Subject: **Rear Hatch Glass, Open Warning Displayed In Multi-Function Display**

Number: **05-05**

Model(s): **Touareg**

Supersedes T.B. Group 55 Number 04-01 dated June 7, 2004 due to bulletin being removed from Required Vehicle Updates category.

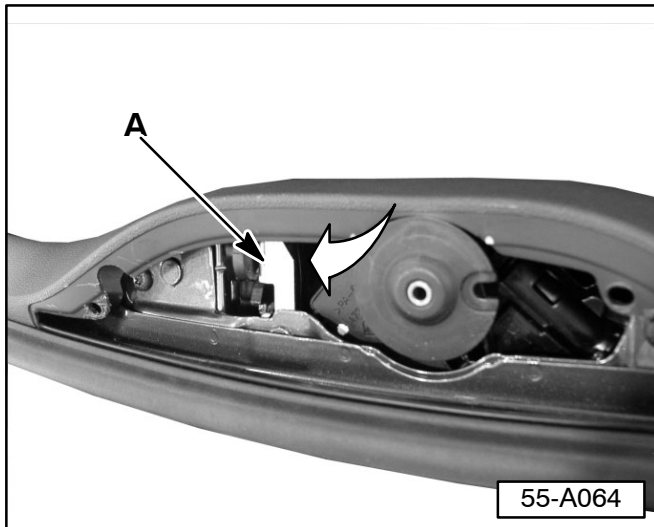
- Open rear window.
- Remove rear wiper motor trim cover.
- ◀ - Check Part No. -white arrow- on side of rear hatch glass latch -A-.

If rear hatch glass latch Part No. is 7L0 827 506D:

- No Service Action Required. Do Not complete this Technical Bulletin.

If rear hatch glass latch Part No. is 7L0 827 506C:

- Replace rear hatch glass latch. See Repair Manual, *Repair Group 55, Hinged Window Lock, Removing and Installing.*

- ◆ Order Part No. **7L6 827 501A** to receive correct part.
